**WHITE LAKE TOWNSHIP
PLANNING COMMISSION**
7525 Highland Road
White Lake, MI 48383
JUNE 3, 2021 @ 7:00 p.m.
Electronic Meeting

Project Name: Pontiac Lakeview Apartments

RE: Pontiac Lake Overlook (FKA Pontiac Lakeview Apartments)- Preliminary Site Plan Review – 4th Review

Subject: Pontiac Lakeview Apartments Preliminary Site Plan Review #4
Tax Parcel No. 12-13-328-001

Existing Conditions Plan
"Pontiac Lake Overlook"
 PART OF THE SW 1/4 OF SECTION 13, T.3N., R.8E., WHITE LAKE TOWNSHIP, OAKLAND COUNTY, MICHIGAN

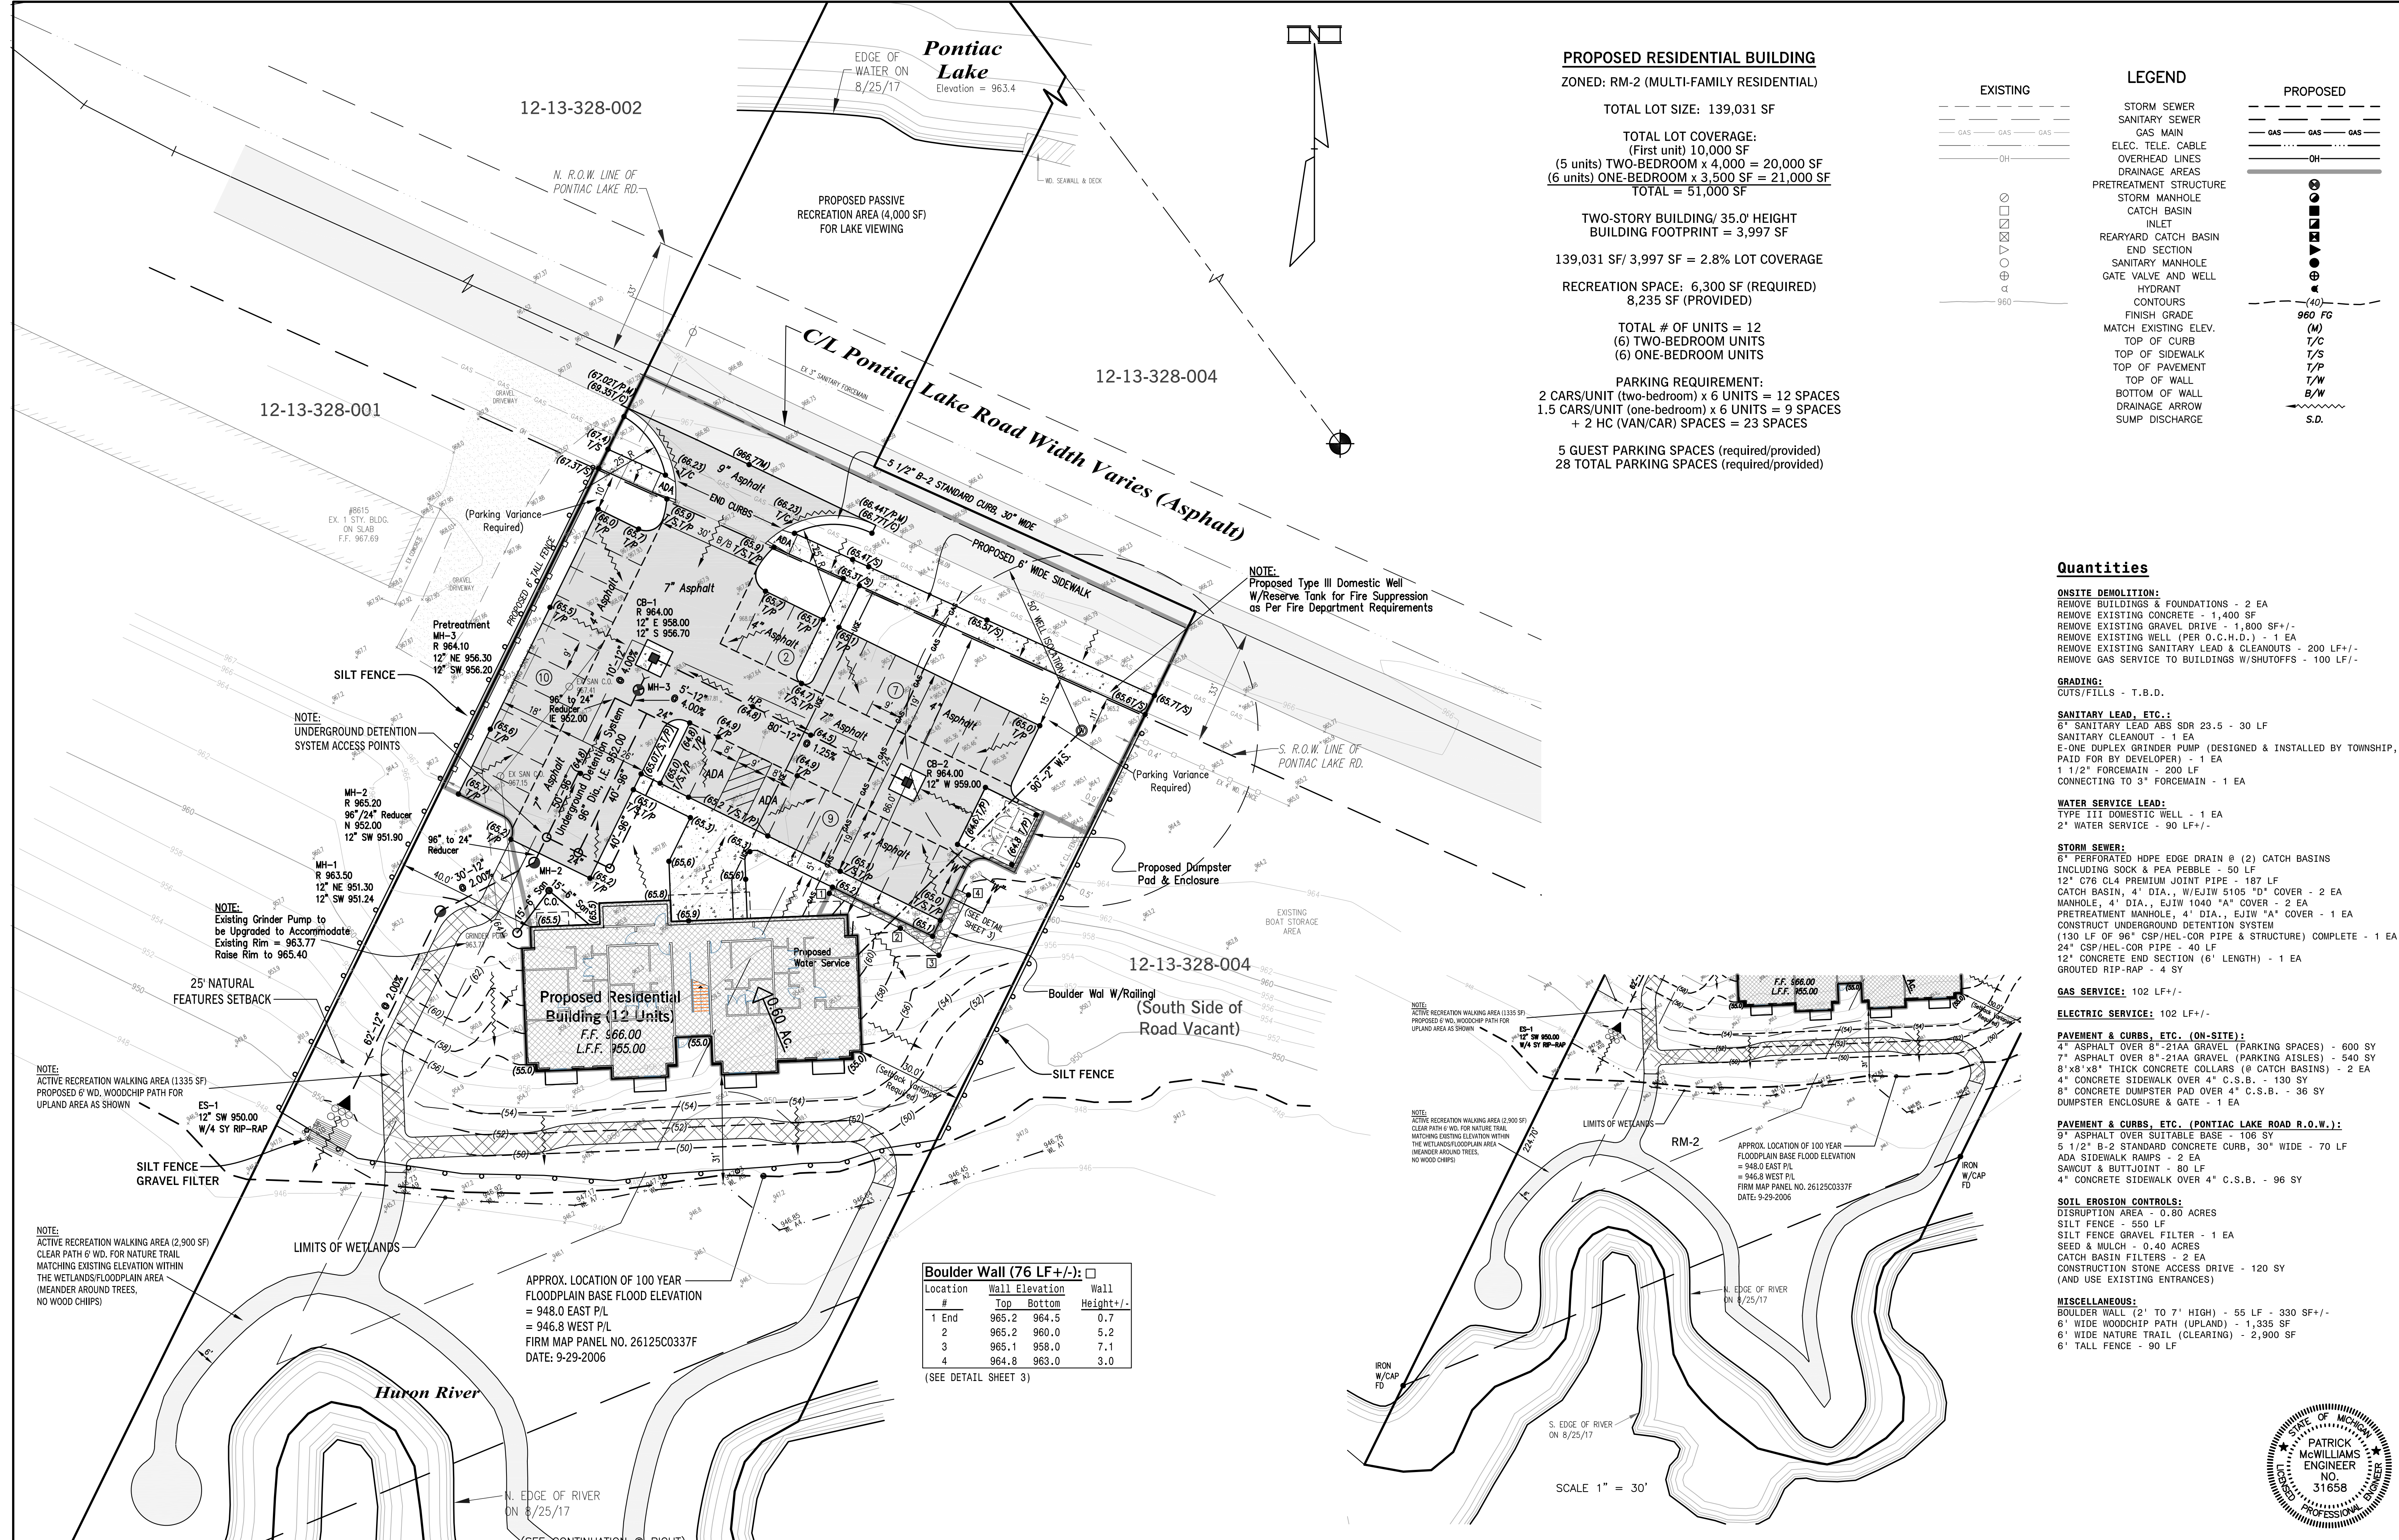
1. *The plans have been sealed by a Licensed Professional Engineer. However, a signature on the seal has not been provided and is required.* **Comment outstanding. A signature in addition to the engineer's seal is required. The design engineer has indicated in their response letter that a signature has been added to their seal on Sheet 1. We are unable to locate signature on the electronic submittal.**
